**SUBJECT:** Contract Change Order No. 10 - between the County of Riverside and Griffith Company for the replacement of Van Buren Boulevard Bridge over Santa Ana River, Riverside Area

**DATE: November 21, 2011  
File: Van Buren Bridge Project  
W.O. No.: B0-0801  
C.C.O.: 10**

**Contract Change Order No. 10**

CONTRACT: **Van Buren Bridge Project** WORK ORDER NO. **B0-0801**

COUNTY OF RIVERSIDE	
VAN BUREN BLVD.	SHEET NO. 59R1
STORM DRAIN PLANS	136 SHEETS
STA 34+00 TO STA 42+70.00	
STA 105+00 TO STA 115+00.00	
PROJECT NO. RD-6801	COUNTY FILE NO.

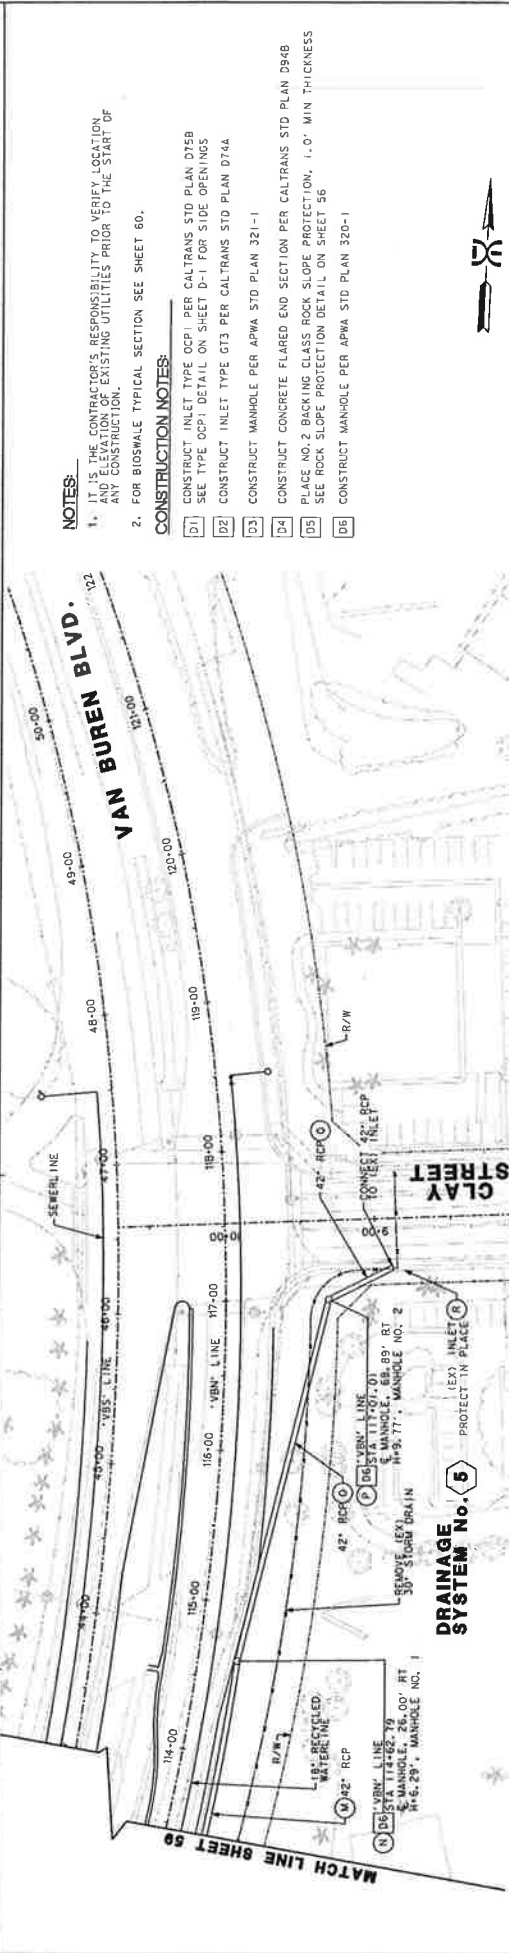
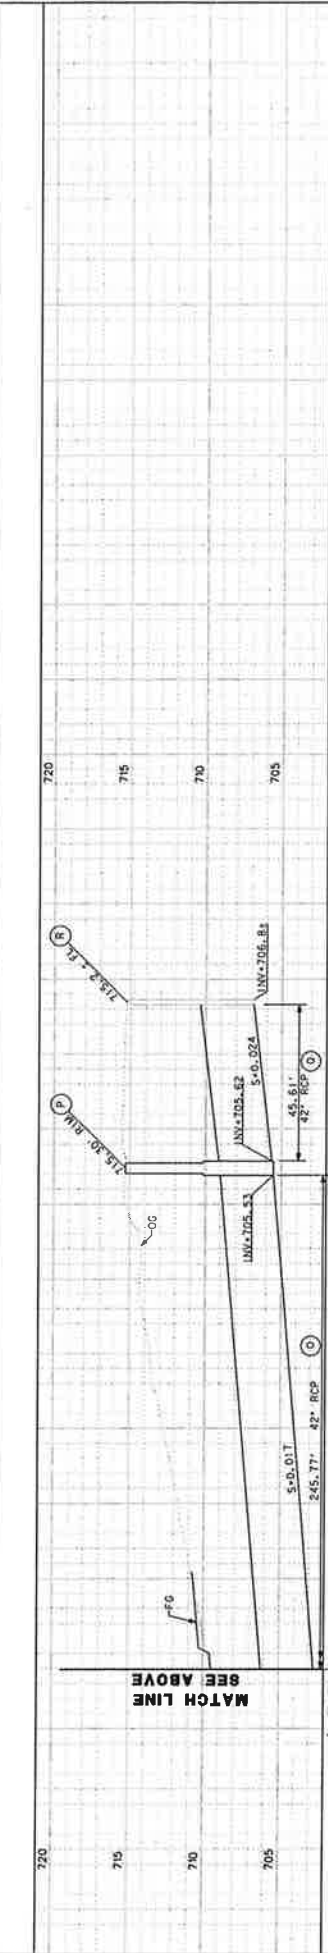
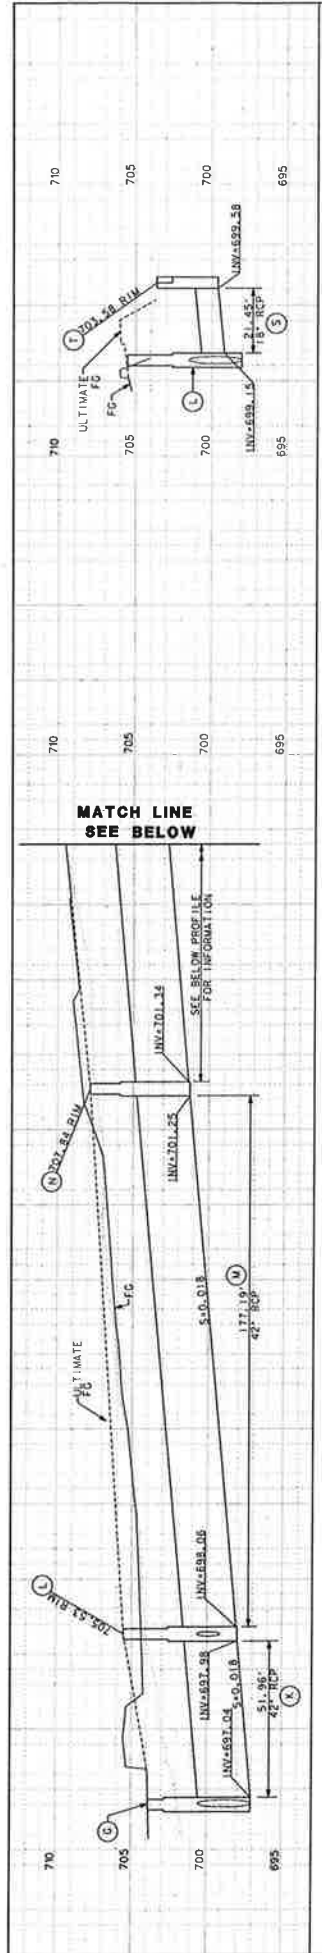
Contract Change Order No. 10 became necessary in order to construct the modification of drainage system no. 5 in accordance with the new/red-lined/revised sheets 59R1, 59A, 59B and 60R2 of 136 of the Van Buren Bridge plans. The storm drain system is modified to accommodate the anticipated increased storm drainage from the proposed Clay St. railroad grade separation project.

As directed by the Engineer and in accordance with the applicable sections of the Special Provisions; compensate the Contractor to construct the modification of storm drain system no. 5 in accordance with the new/red-lined/ revised plans sheets 59R1, 59A, 59B and 60R2 of 136 and numbered as sheets 3 thru 6 of this contract change order. The modification is in anticipation of the Clay St. railroad grade separation project which will result in increased drainage discharge to the existing storm drain system. The unit prices include; but not limited to, furnishing labor, equipment and materials in completing the work in place as follows:
